Garrisons Lake Boat Ramp Reconstruction
DFW Contract No. NAT20001-Garrisons

Addendum 2: Question Responses and Drawing Revisions

GARRISON'S LAKE BOAT RAMP RECONSTRUCTION

C105

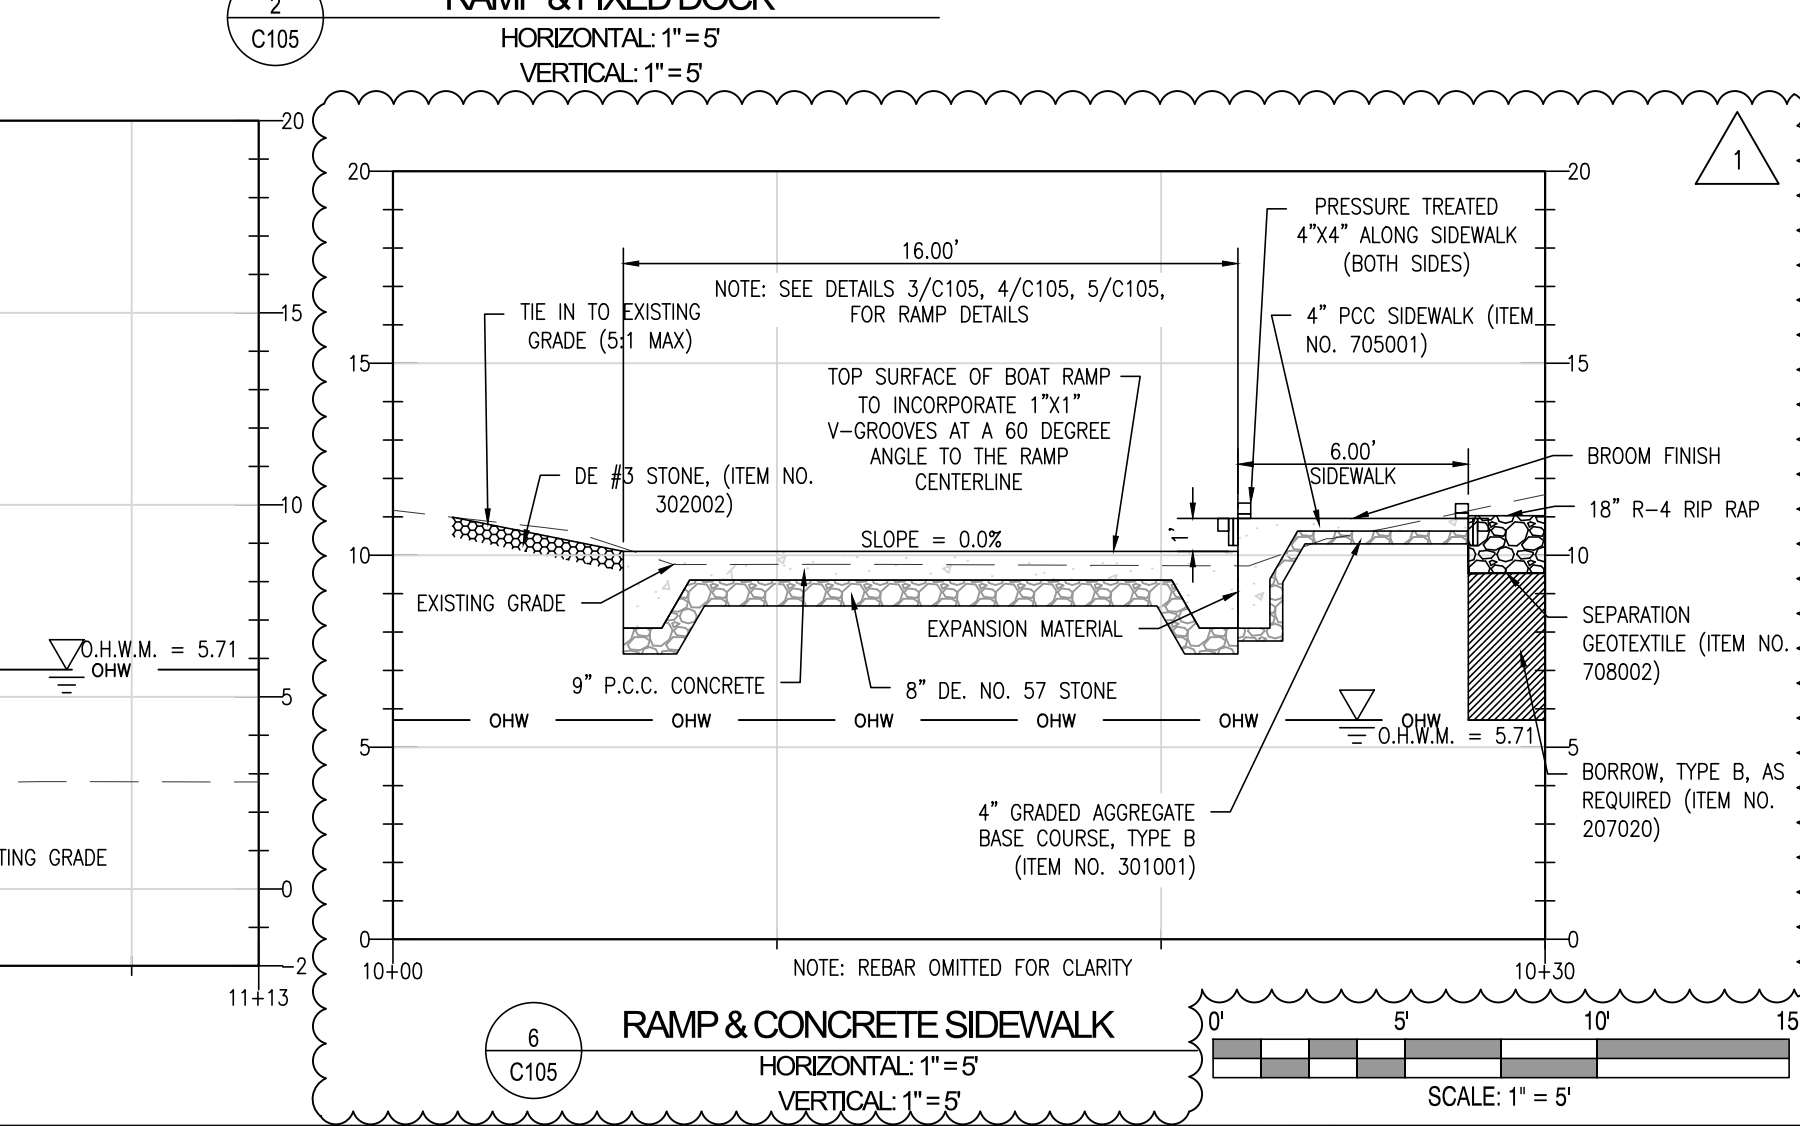
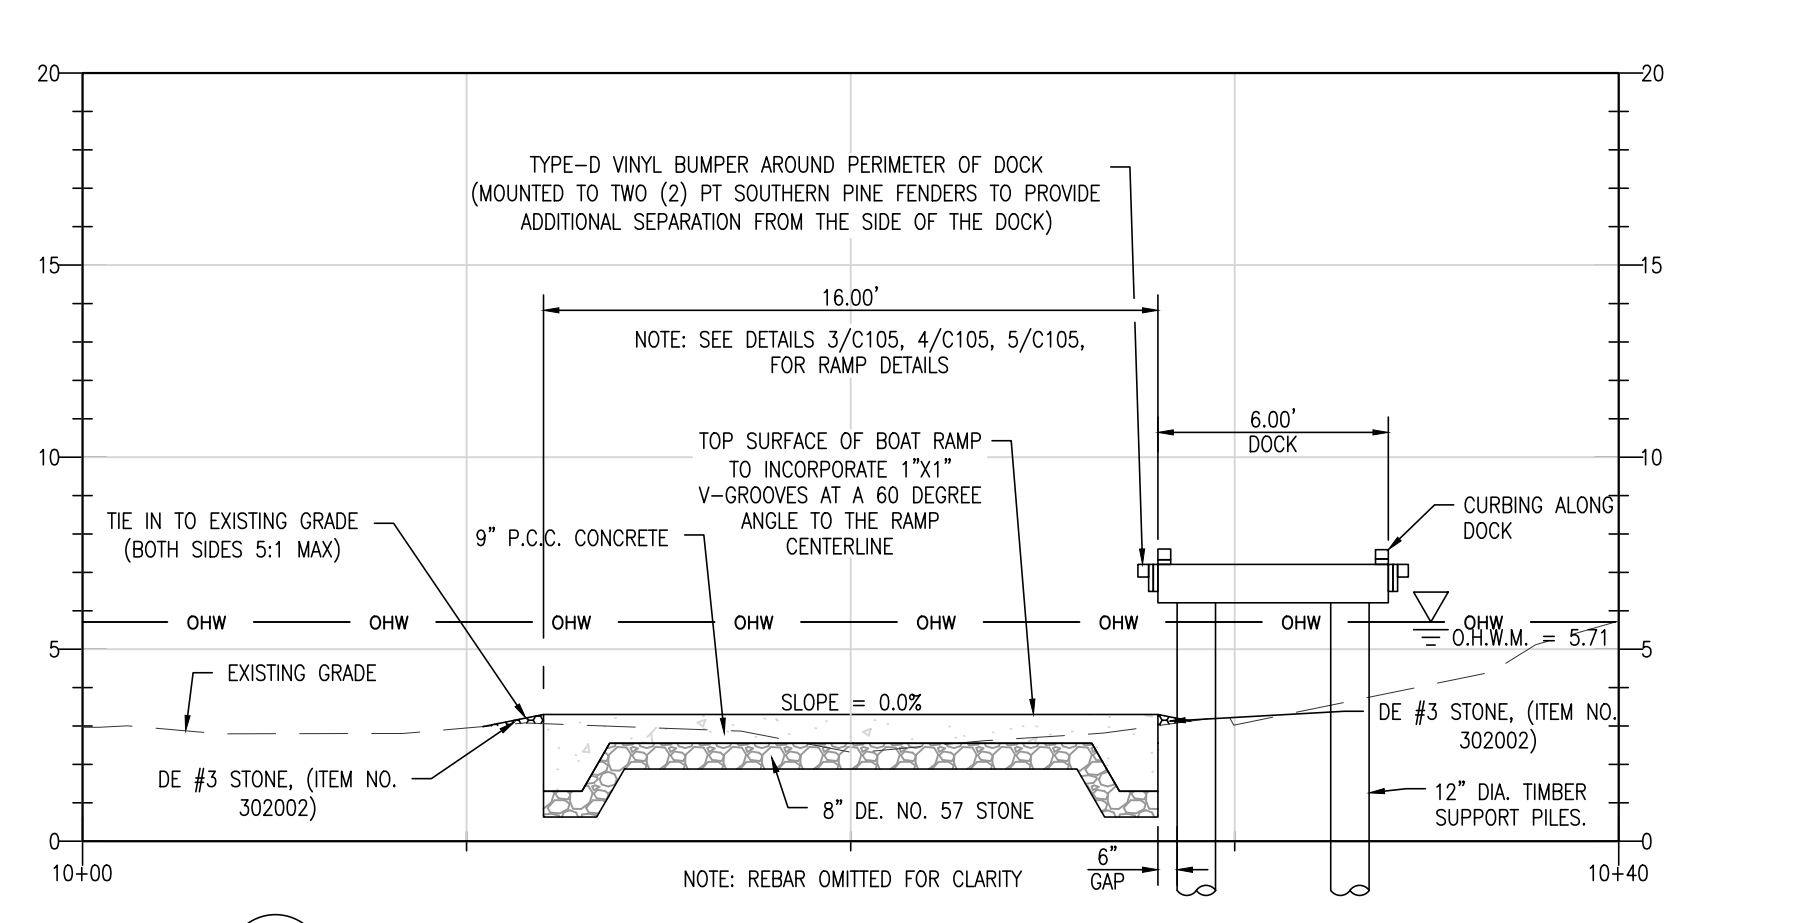
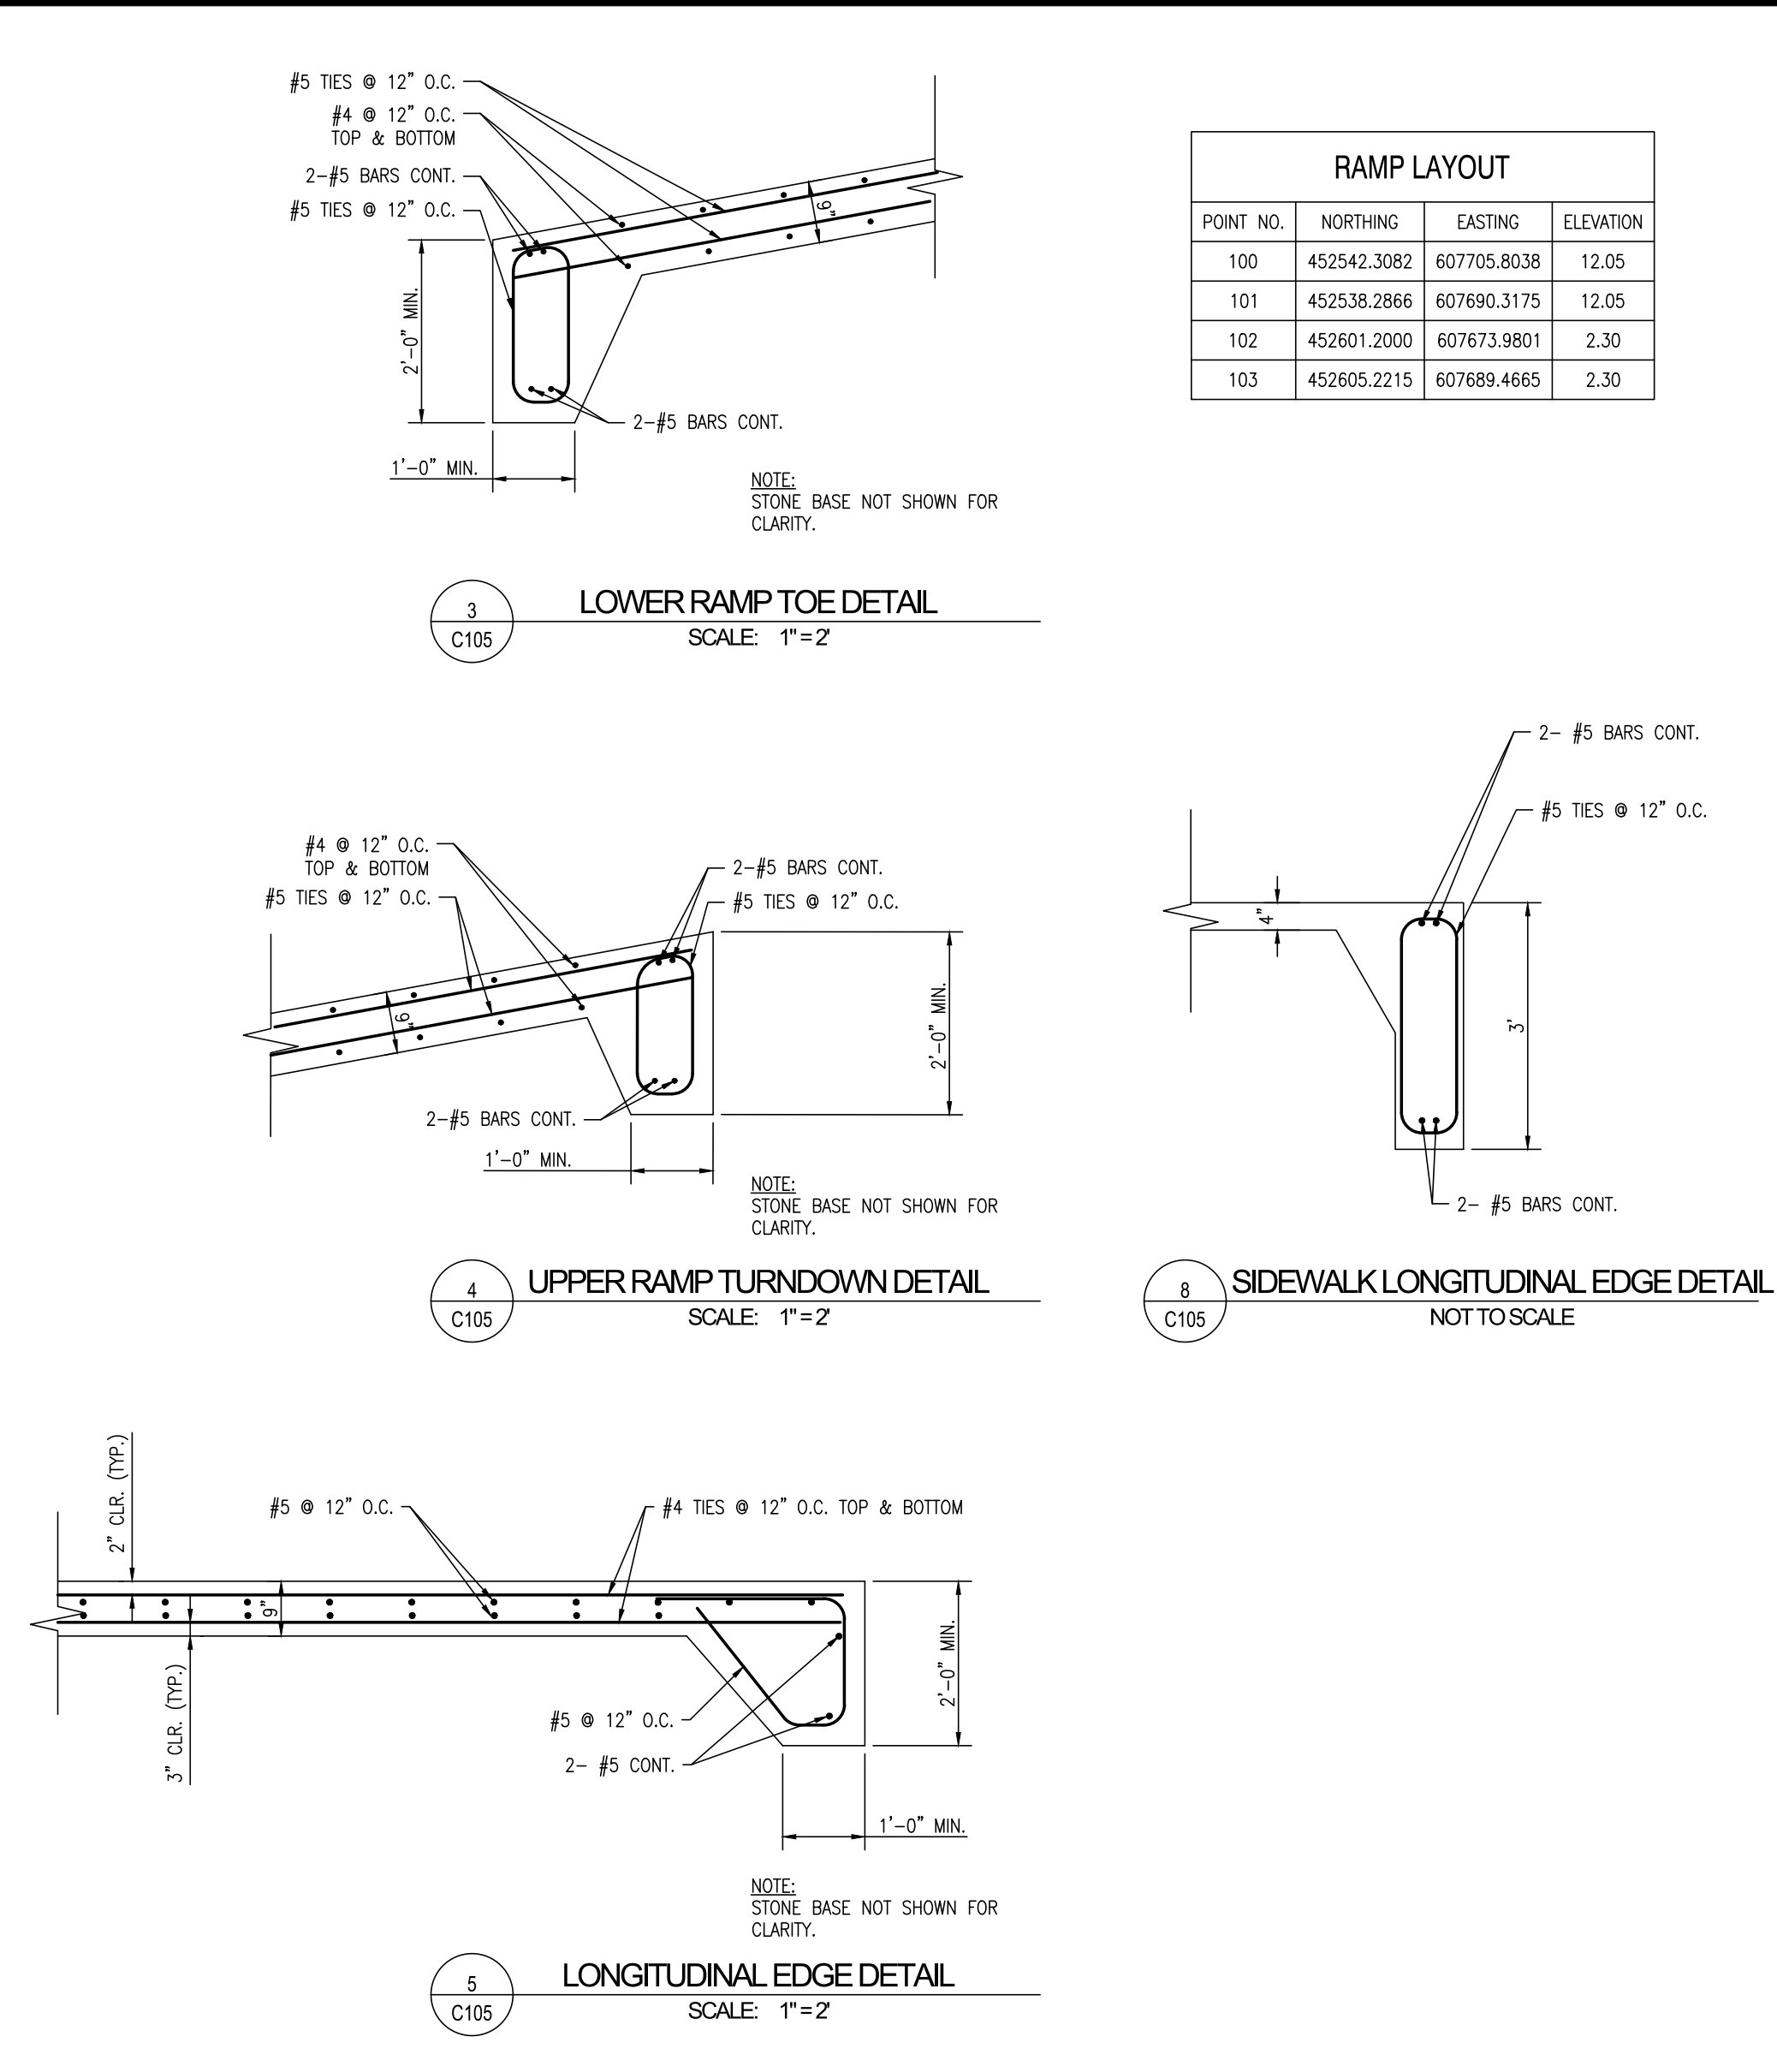
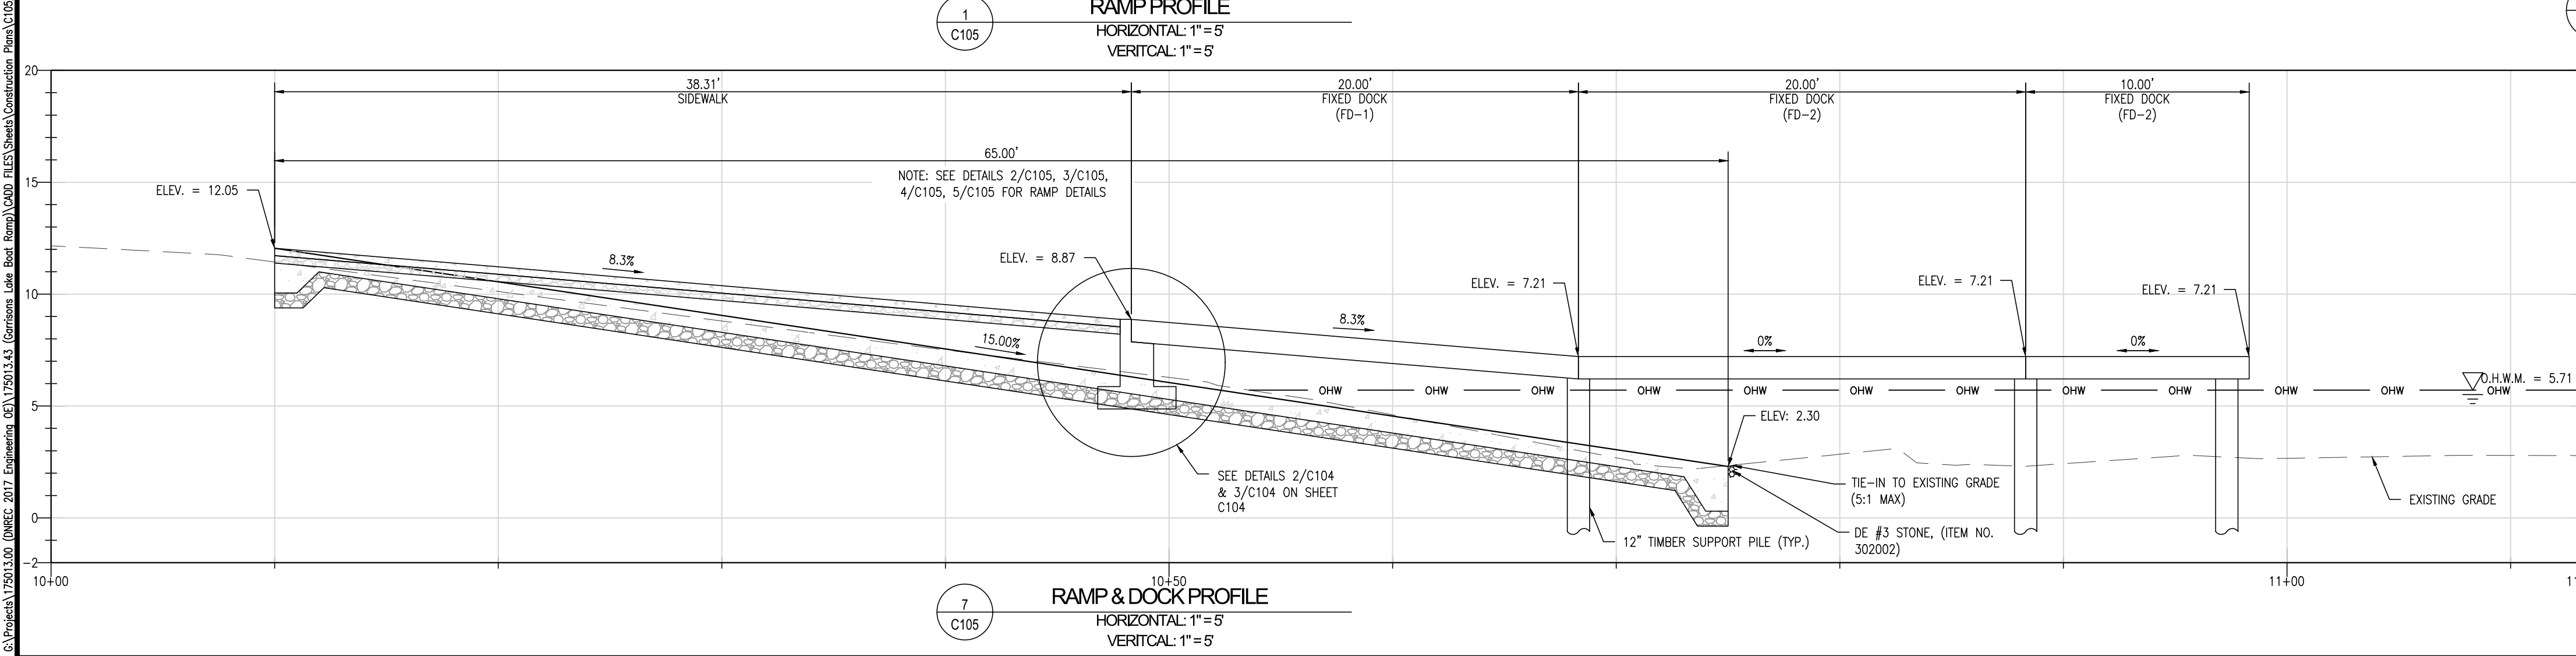
1. Section 6/C105 shows what appears to be vinyl D bumper on wood fenders mounted to each side of the sidewalk. Is this required on the sidewalk since it is above OHW elevation and one side is buried in riprap?

- a. RESPONSE: Bumper is to be placed on sidewalk to provide protection from trailers and vehicles.
2. Section 6/C105 shows 4" x 4" curbs at each edge of the sidewalk. The plan view on the same plan page shows aluminum handrail on the riprap side. Please clarify if you want the curb or handrail on the riprap side of the sidewalk.

- a. RESPONSE: Handrails are to be placed on rip-rap side. Handrail will be included in the GatorDock equipment/material provided by Division of Fish and Wildlife.

REVISIONS	
ADDENDUM	
DESCRIPTION	DATE
PROVIDED NEW DETAIL 6/C105, 11/03/2020
